Internal Service Bulletin for JLG Use Only

ISB 10-20

<u>Release Date:</u>	July XX, 2010
<u>Subject:</u>	Elevation Switch Cover
<u>Product Type:</u>	Scissors
<u>Models Affected:</u>	ES Scissors
<u>Switch</u>	Rotary Angle Sensor
<u>Part Numbers Involved:</u>	1001092354 (Switch Assembly), 1001121241 (Service Kit)

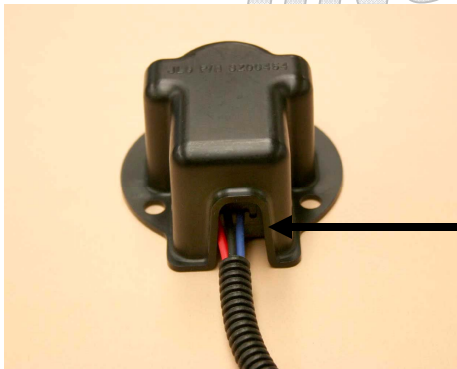
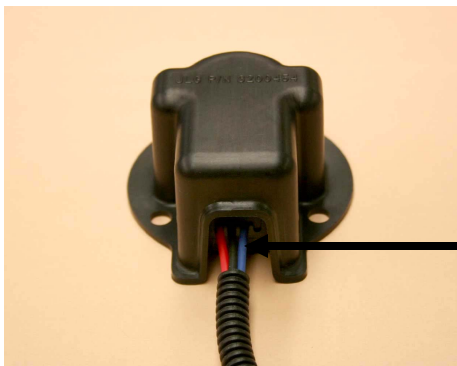
A change was made to the cover supplied on elevation rotary angle sensor (1001092354). The cutout width was increased to allow clearance for the wires to eliminate the rubbing condition which could result in the sensor not operating properly. Photos below show the affected part.

Original cover shows wires exiting off center of the cover causing the rubbing condition.

Modified cover shows wires centered exiting cover eliminating the rubbing condition.

A service kit# 1001121241 has been created. This kit contains an updated cover (3200454) and the rotary angle sensor which needs to be used in place of the original. Any time a customer orders the original switch number he will receive the service kit in it's place. The customer should discard the original cover and replace it with the new cover.
